Subject: Oyster Creek Nuclear Generating Station
Facility License No. DPR-16
Docket No. 50-219
Response to Request for Additional Information re:
Proposed License Amendment for Spent Fuel Pool Expansion

Enclosure 1

Two Dimensional Array of N Bodies (N=13)

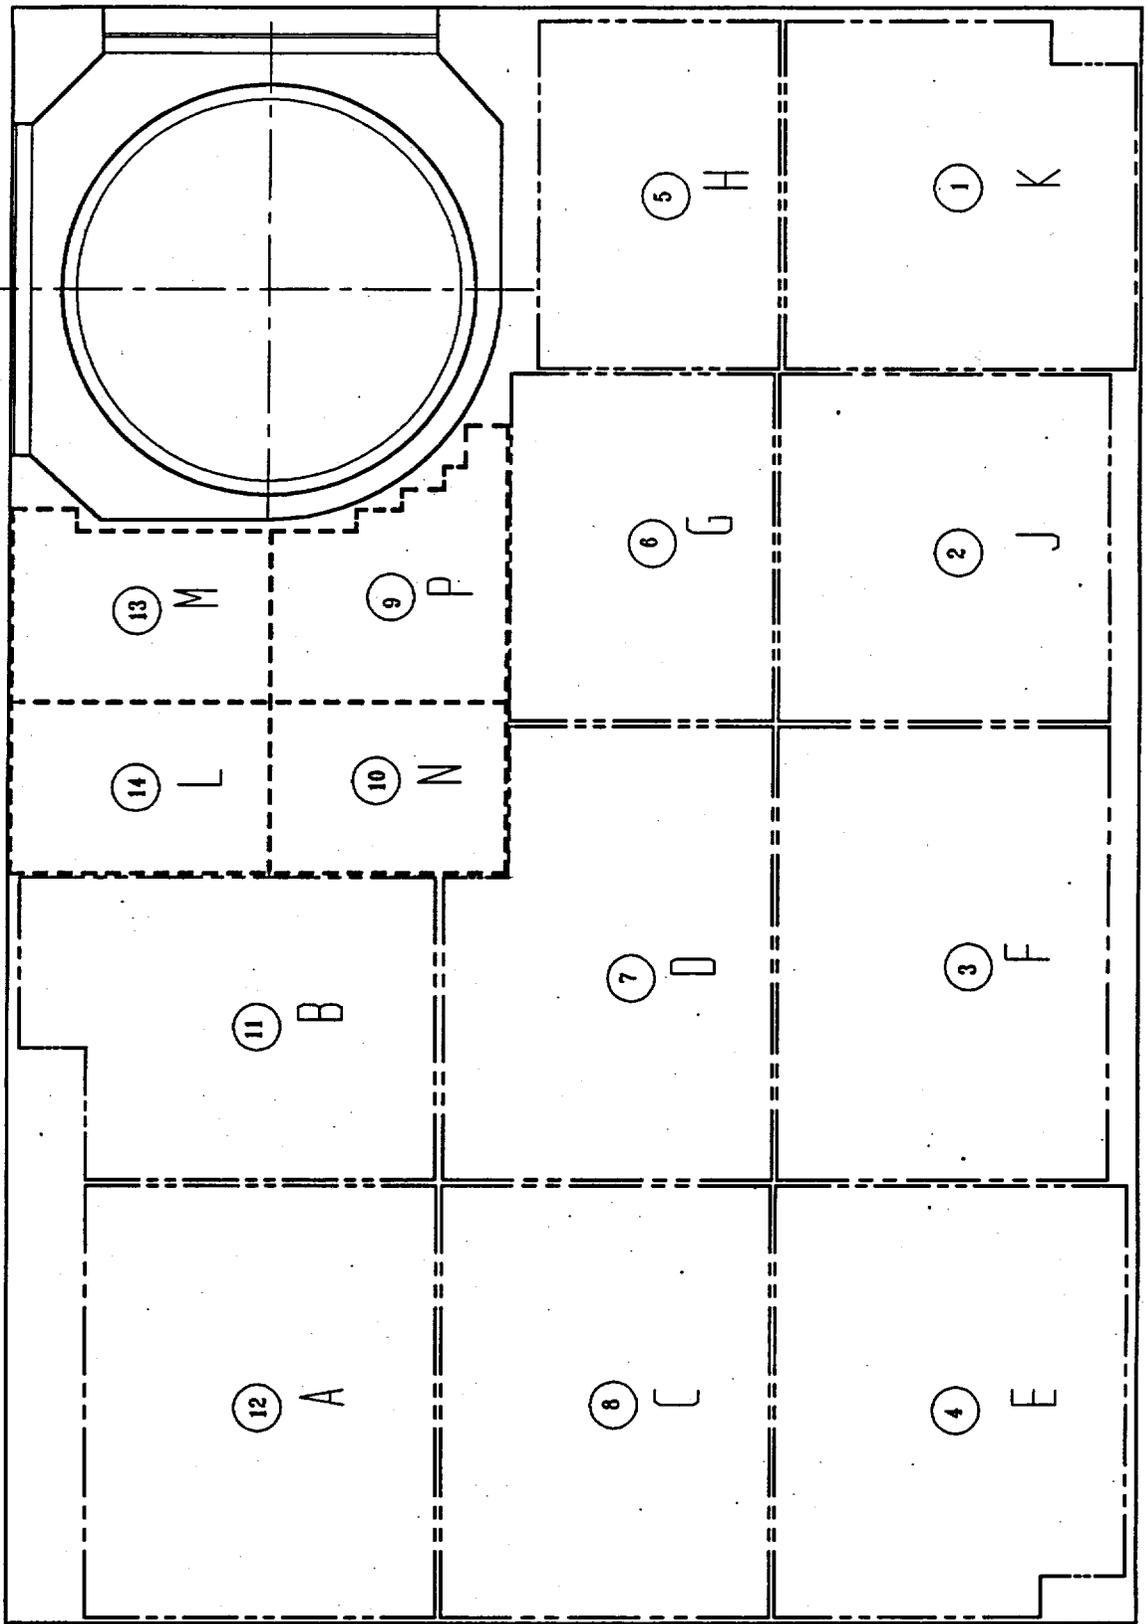
- (b) Provide the results of any prototype experimental study that verifies the correct or adequate simulation of the fluid coupling utilized in the numerical analyses for the fuel assemblies, racks and walls. If no such experimental study is available, explain how the current level of DYNARACK code verification is adequate for engineering application without further experimental verification work.

A key ingredient in the Whole Pool Multi-Rack (WPMR) analysis is quantification of the hydrodynamic coupling effect that couples the motion of every rack with every other rack in the pool. In 1987, Dr. Burton Paul (Professor Emeritus, University of Pennsylvania) developed a fluid mechanics formulation using Kelvin's recirculation theorem which provided the fluid coupling matrix ($2n \times 2n$ for a pool containing n racks). For example, with reference to Attachment 1.1, where an array of N ($N = 13$) two-dimensional bodies (each with two degrees of freedom) is illustrated, the dynamic equilibrium of the i -th mass in the x -direction can be written as:

**OCNGS Spent Fuel Pool Rack Layout
W/Gap Dimensions**

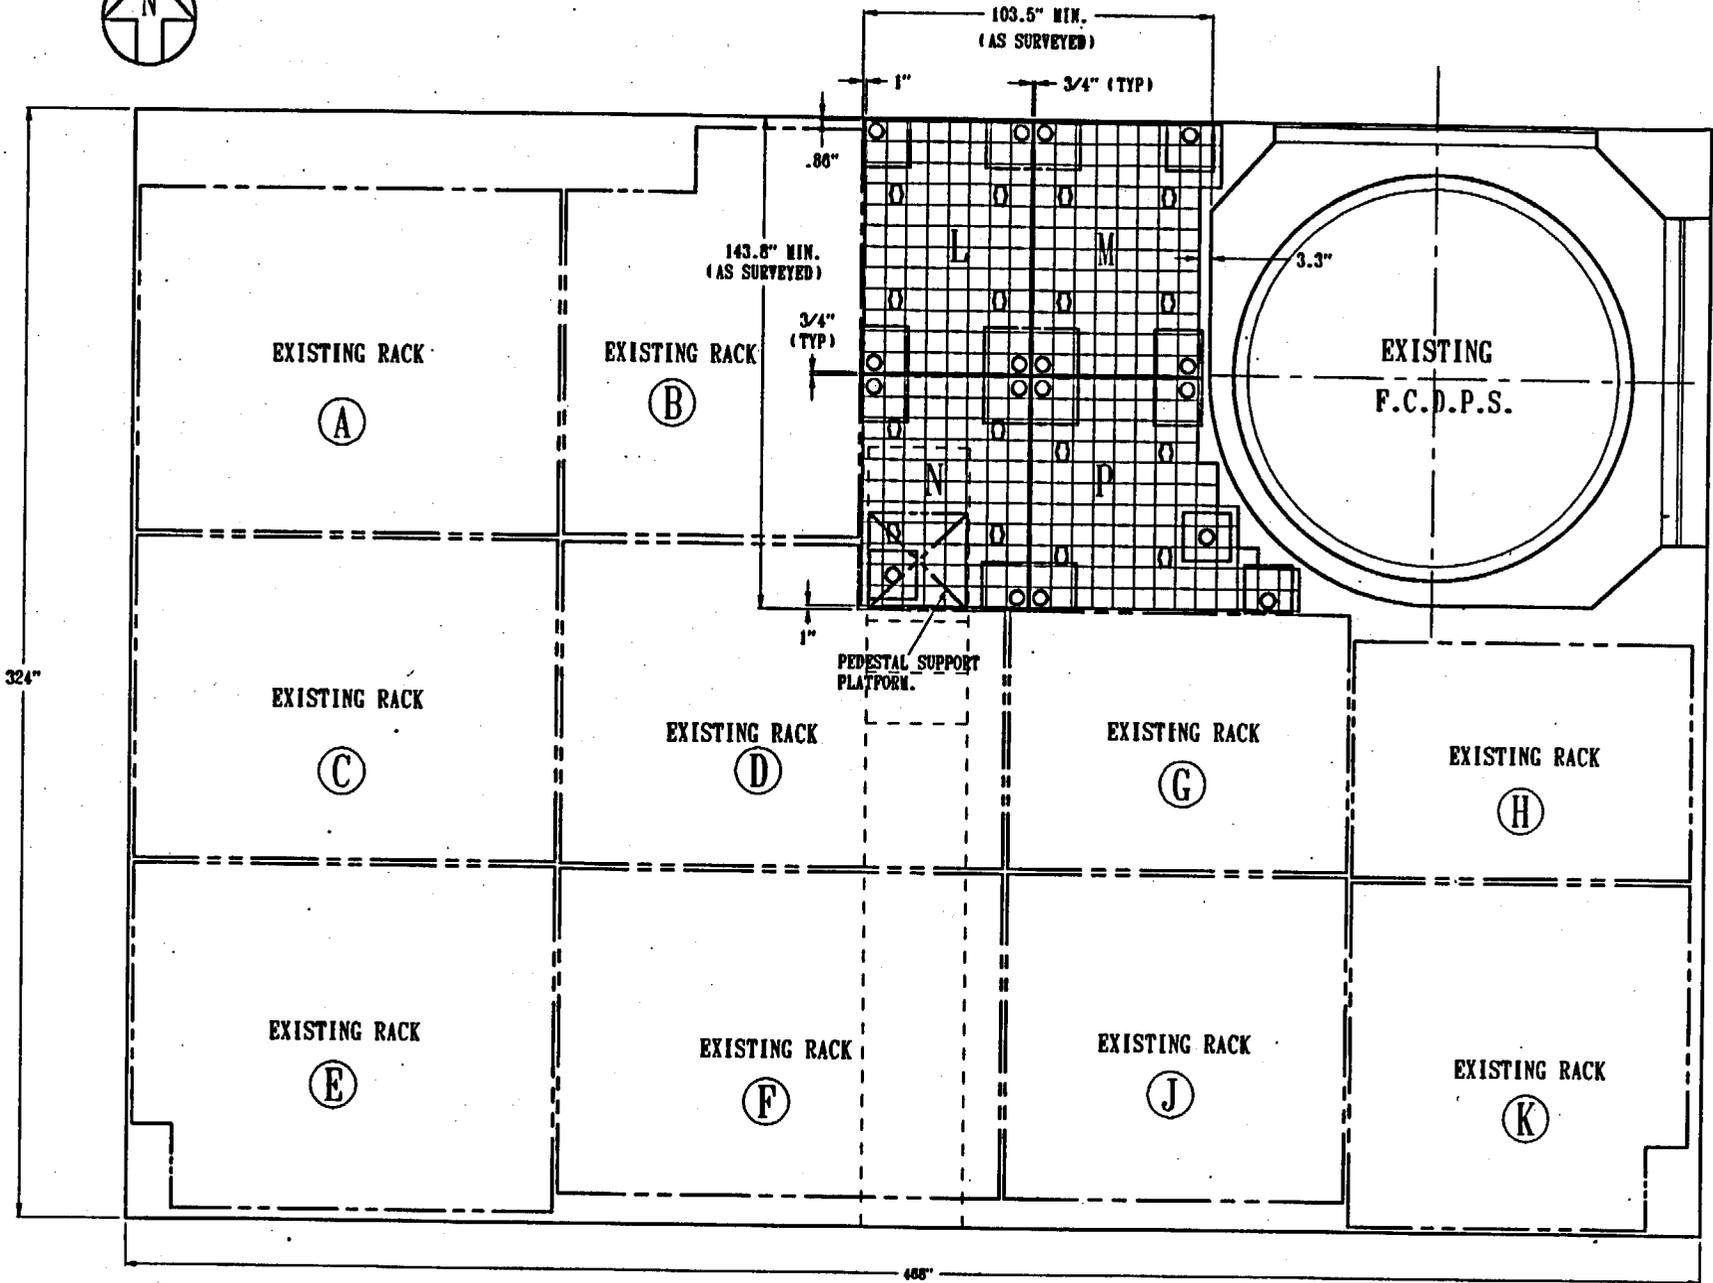
- (c) Provide the physical dimensions of the racks, and the gaps between the racks and the gaps between the racks and the spent fuel pool (SFP) walls.
- (d) Demonstrate that the artificial seismic ground motion time histories used in the analyses satisfy the power spectral density (PSD) requirement of SRP 3.7.1.

Attachment 1.2 shows the gaps between the racks and the gaps between the racks and the spent fuel pool (SFP) walls.
